Time to take a stand – the proposed new Ben More hydro track

On 7th July, an application for a new hydro scheme on the slopes of Ben More by Crianlarich, one of the highest and best known Munros, was validated on the Loch Lomond and Trossachs Planning Portal ([see here](#)) (or if the link does not work go to <http://www.lochlomond-trossachs.org/planning/planning-applications/find-an-application/> and search for application Ref 2017/0119/DET or on Benmore farm). On Friday I went to have a look and have now submitted an objection to the application as currently proposed (appended to end of this post). This post is about

Proposal: Construction of a run of river hydropower scheme

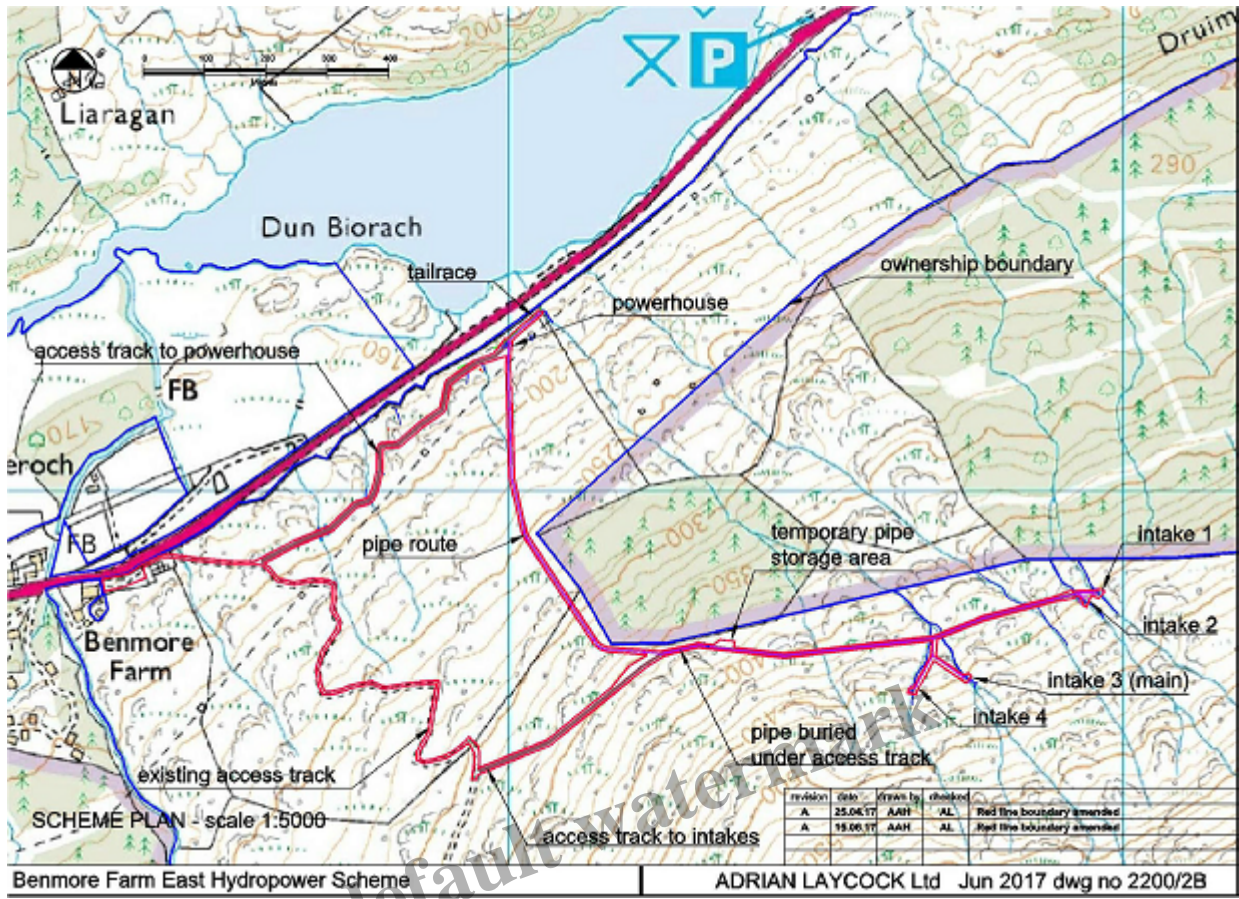
When you approach the intake though the most obvious feature is the metal fencing – contrary to Park guidance on use of natural materials (but is it really necessary?) – and the Lomond blue pipe. Its a shame that the left side of the intake has not been finished like the right had side but it does show, I think, what can be done. Well done somebody!

Part of the Allt Essan hydro scheme on the north side of Glen Dochart – powerhouse centre

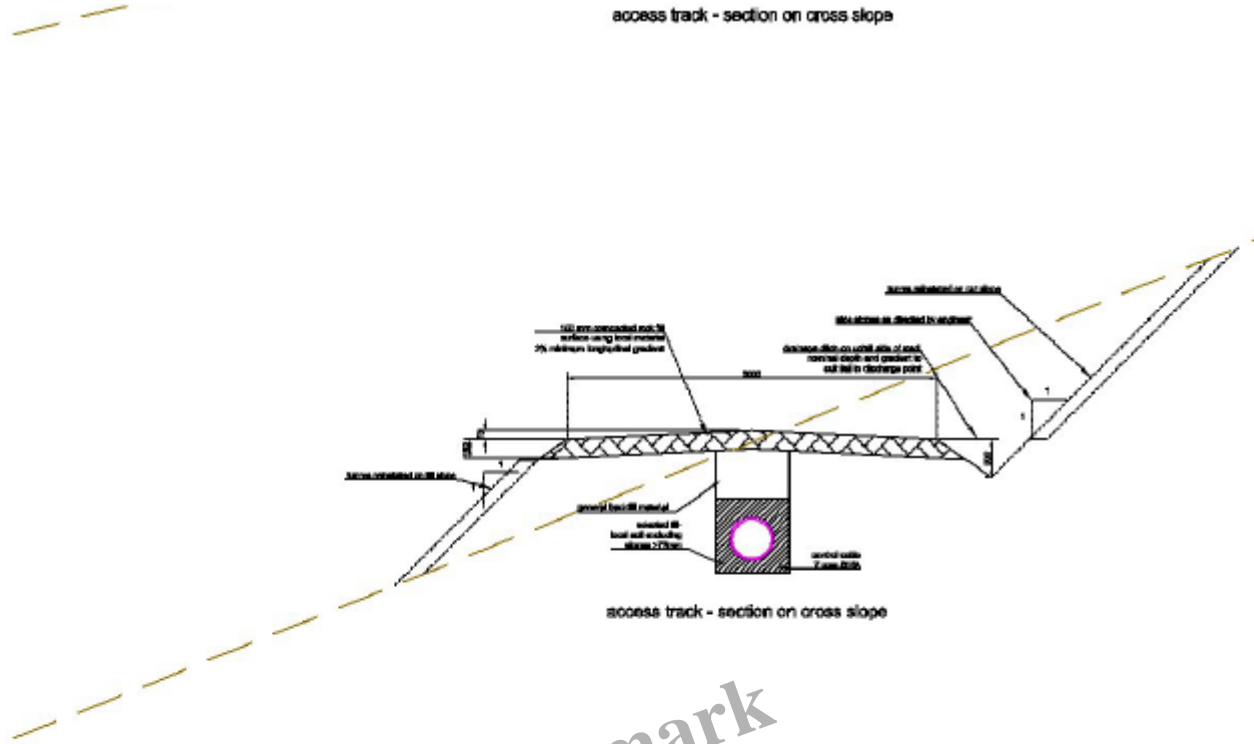
What prompted me to visit the location the scheme was the proposal to retain the new access tracks. Having removed the construction tracks to the intake in the Benmore Burn scheme, I wanted to understand why Benmore Farm were proposing to retain the construction tracks to the new intakes. Part of me reckons that this is because since 2013, when the first scheme was approved, the LLTNPA as Planning Authority have moved from a position of assuming tracks should be removed to allowing them to remain everywhere.

So, if other people are getting away with it, why should Benmore Farm follow best practice? That's why people need to take a stand. The proliferation of hill tracks is destroying the landscape in the National Park – and indeed across Scotland – and those who care about the landscape need to put a stop to this.
